SCI-823-0.00
PID Nos. 19415, 77366, 79977

Value Engineering Study Report
Draft Stage 2 Design Phase

re: SCI-823-0.00, PID Nos. 19415, 77366 and 79977, Portsmouth Bypass
Harrison, Jefferson, Madison and Porter Townships, Scioto County
Value Engineering Study Report

DESIGN AGENCY: **TransSystems**
 DATE: 9/28/07
 REVIEWED: MSL
 DRAWN: PJP
 CHECKED: MSL
 STRUCTURE TITLE NUMBER: 7306326
 SCIO TO COUNTY STA. 112+84.14
 STA. 117+64.86
 BRIDGE NO. SCI-823-0214 L
 S.R. 823 OVER CSXT RAILROAD
 SITE PLAN
 SCI-823-0.00
 PID 77366
 1/8

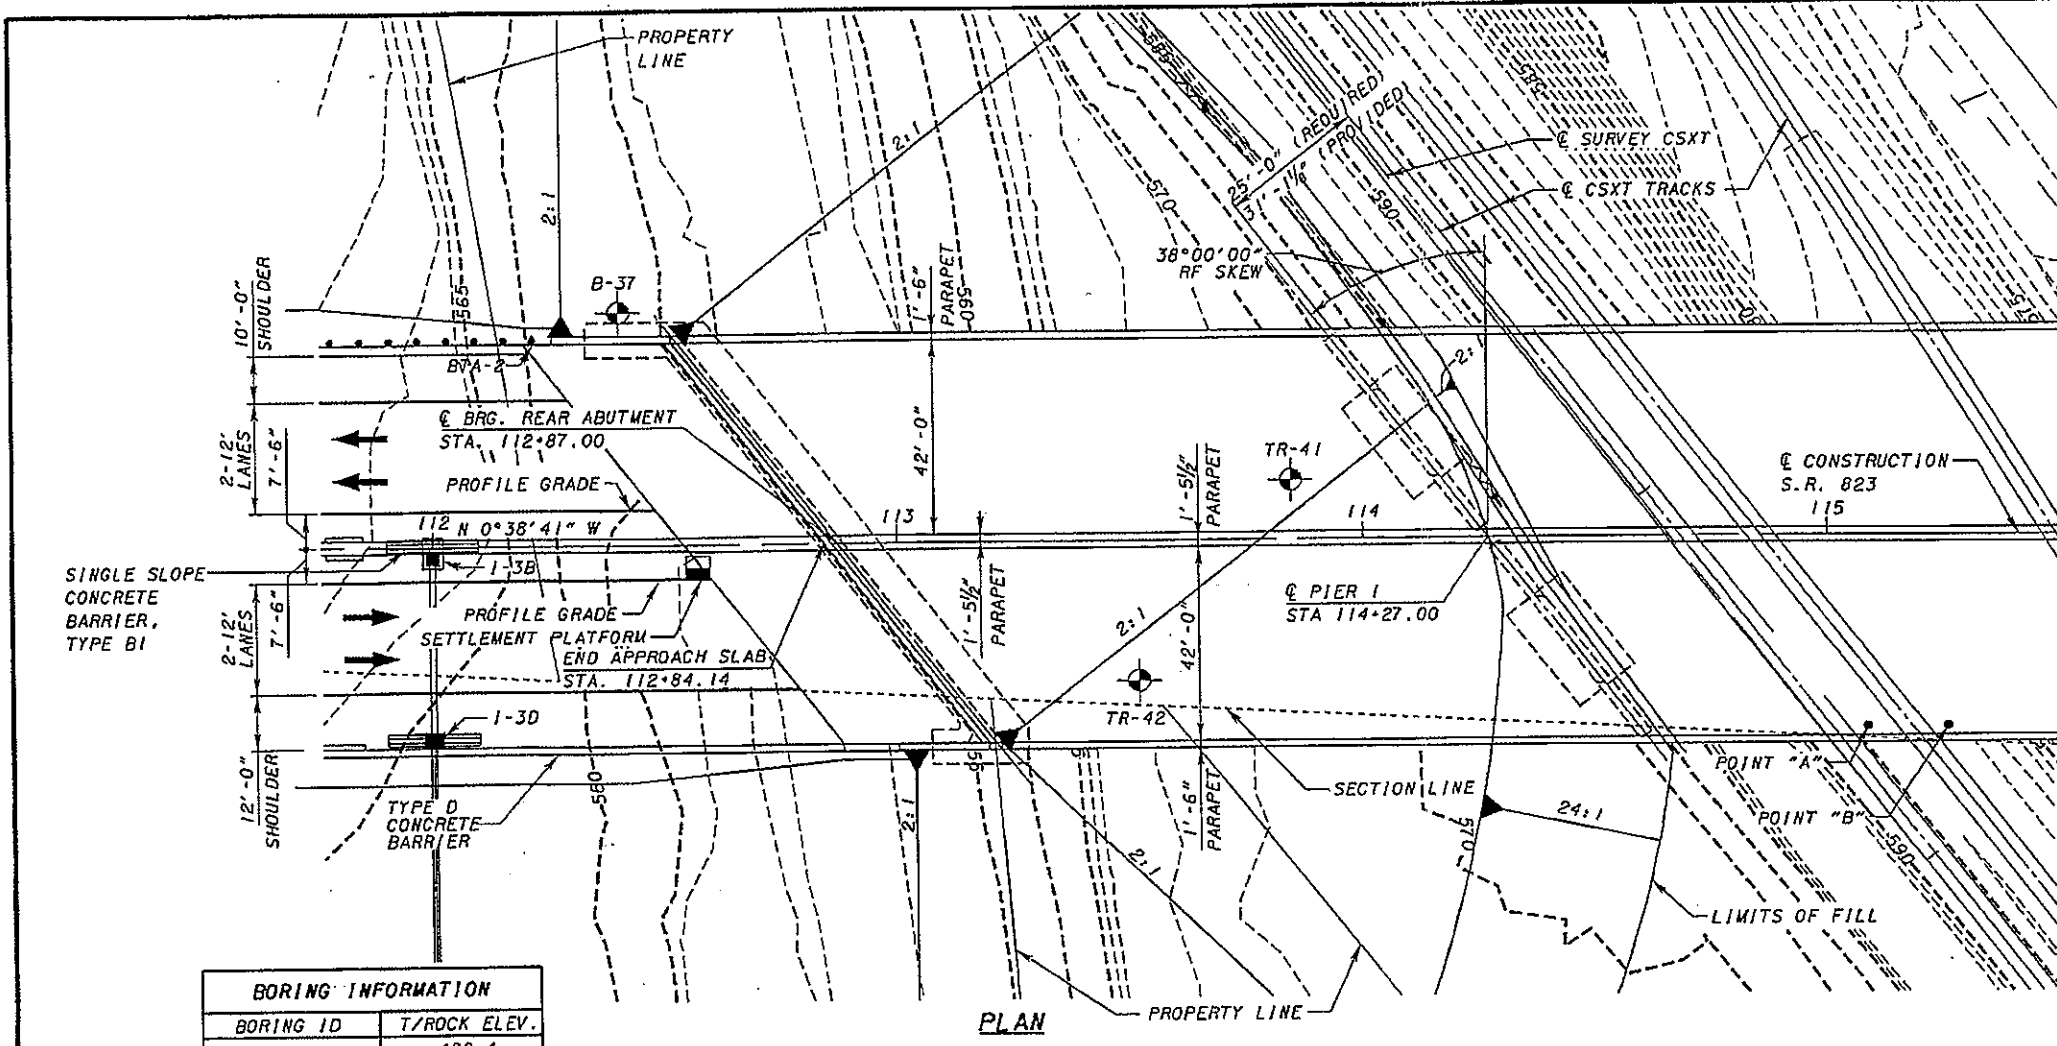
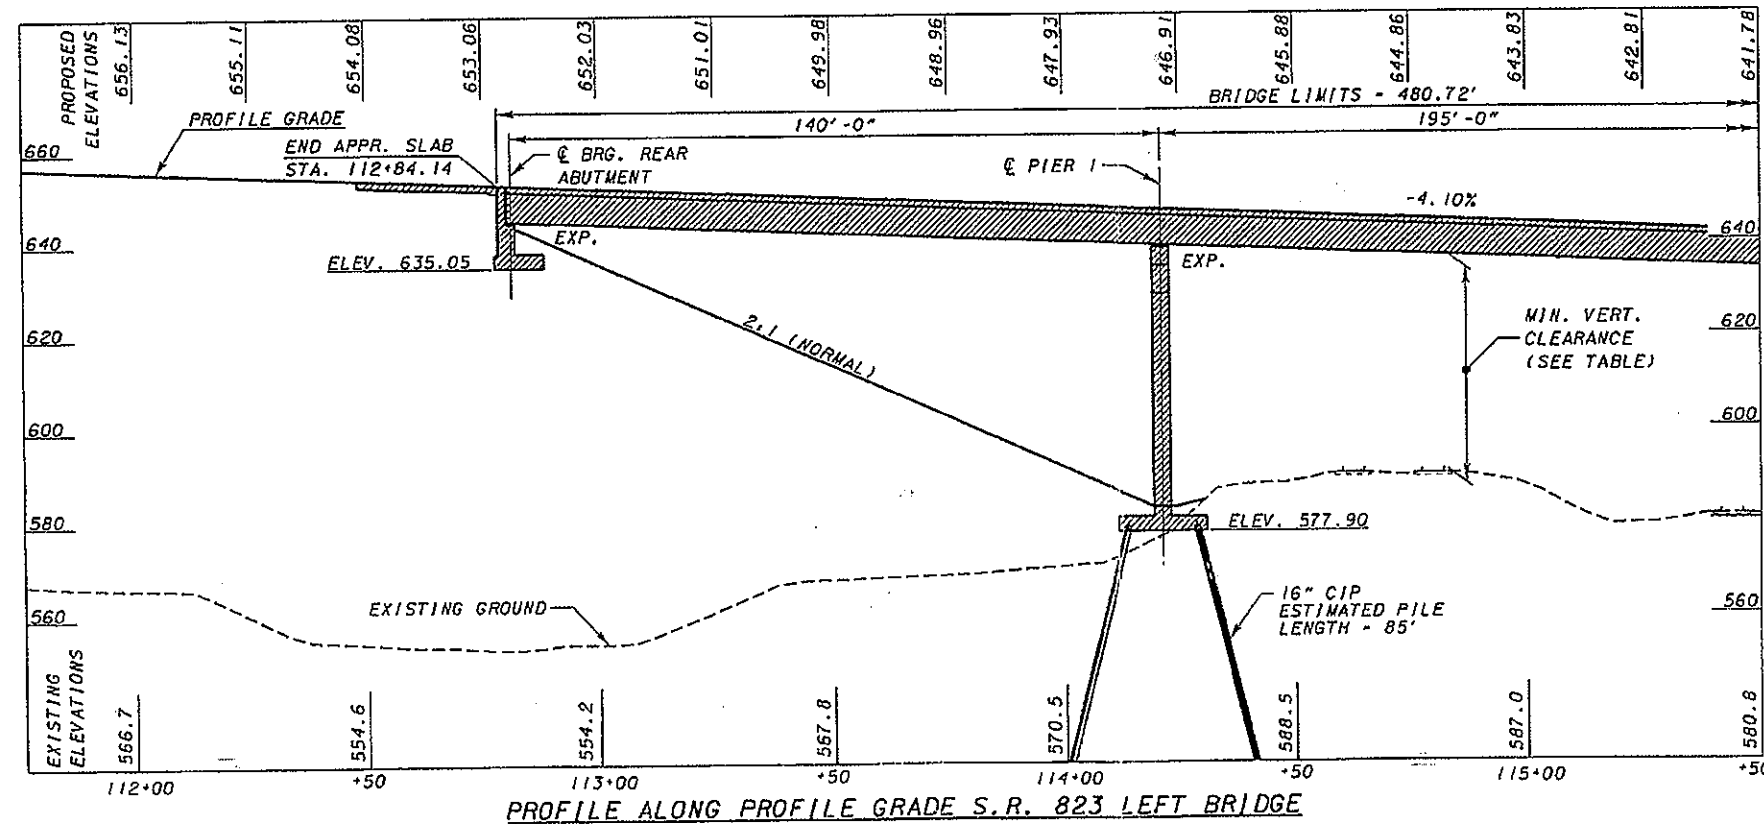
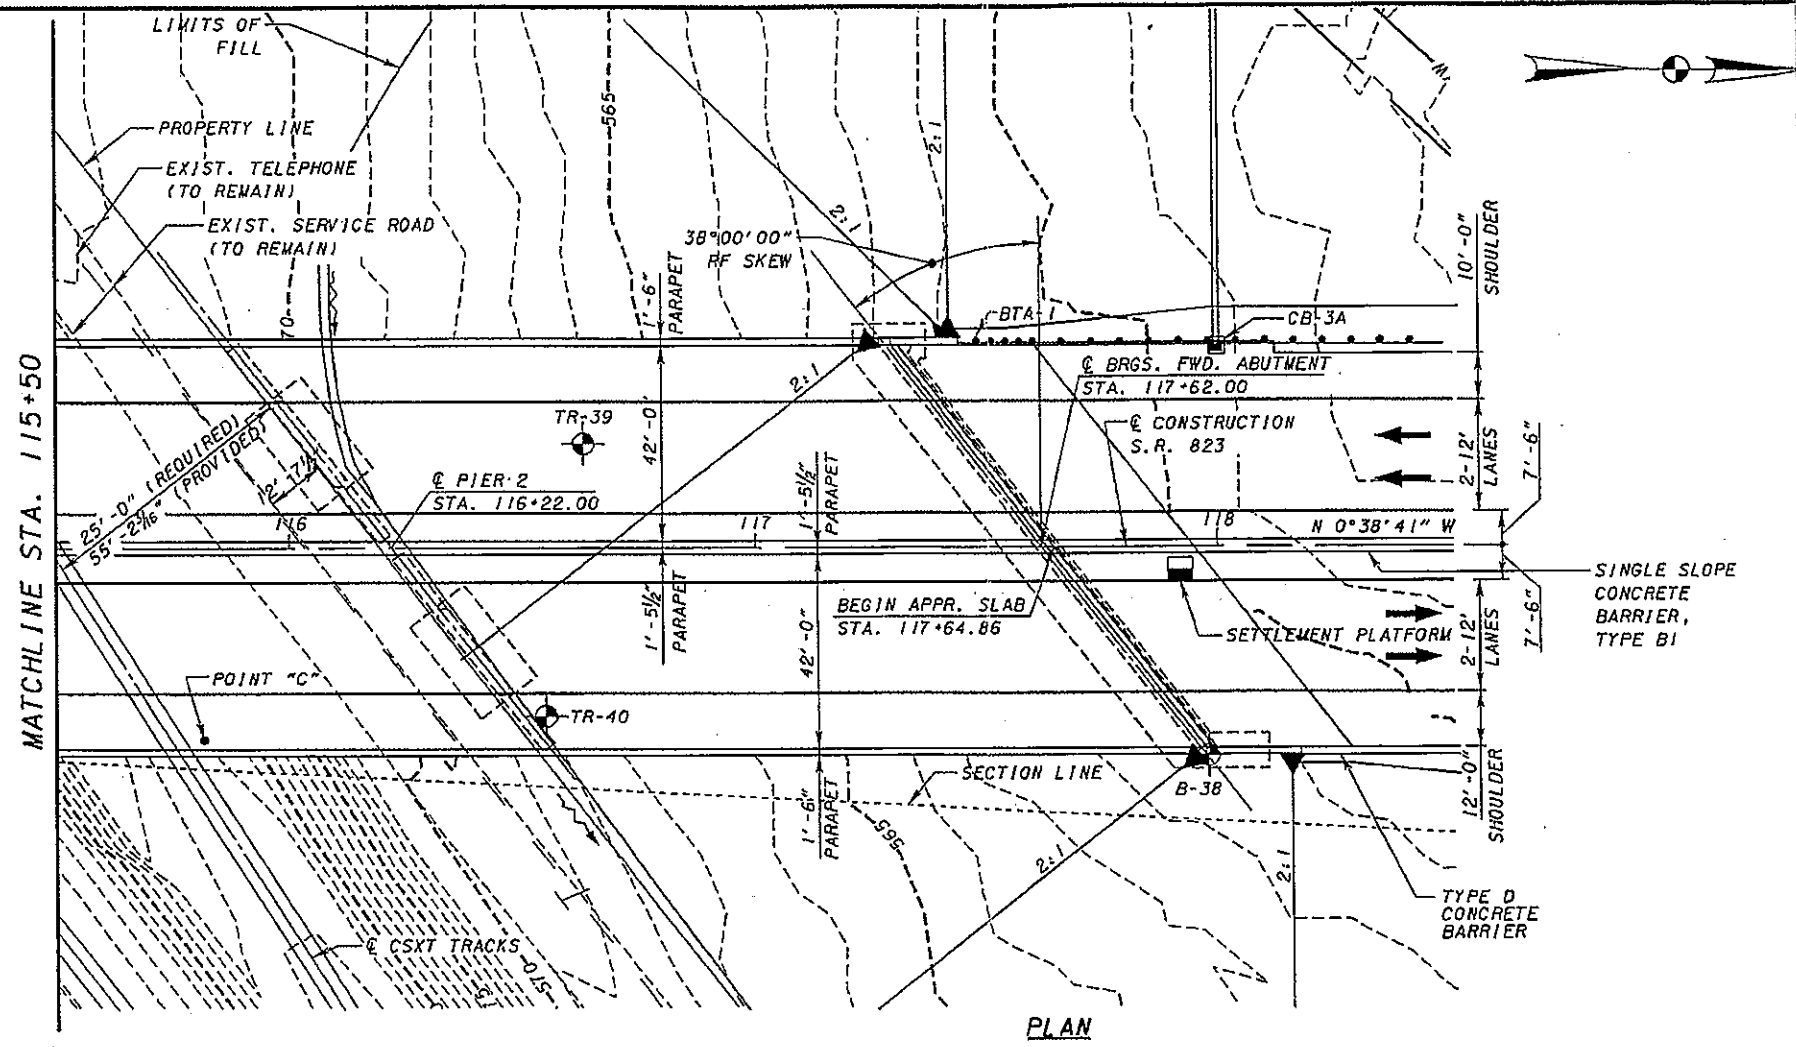
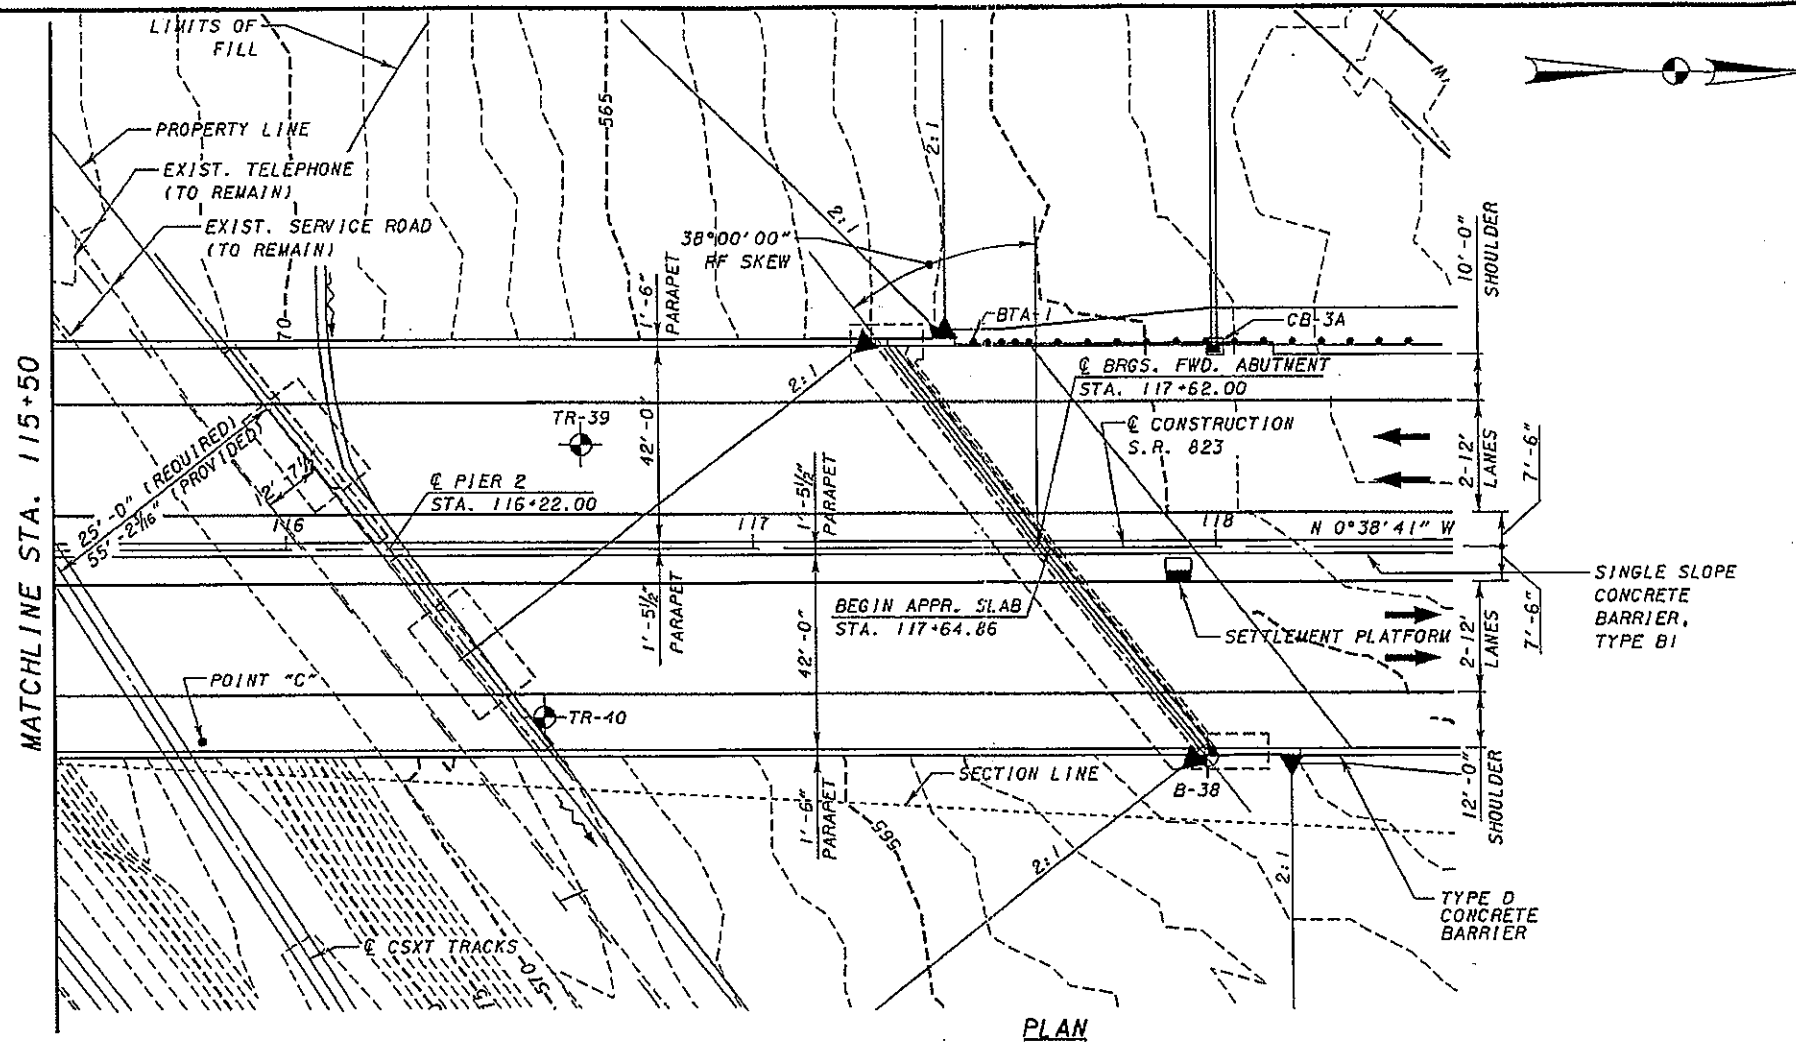
- SCI-823-0067 L - See Alt. No. 65;
- SCI-823-0074 R - No change;
- SCI-823-0117 L - No change;
- SCI-823-0122 - No change;
- SCI-823-0214 L & R - Potential to shorten end spans approximately 10 each;
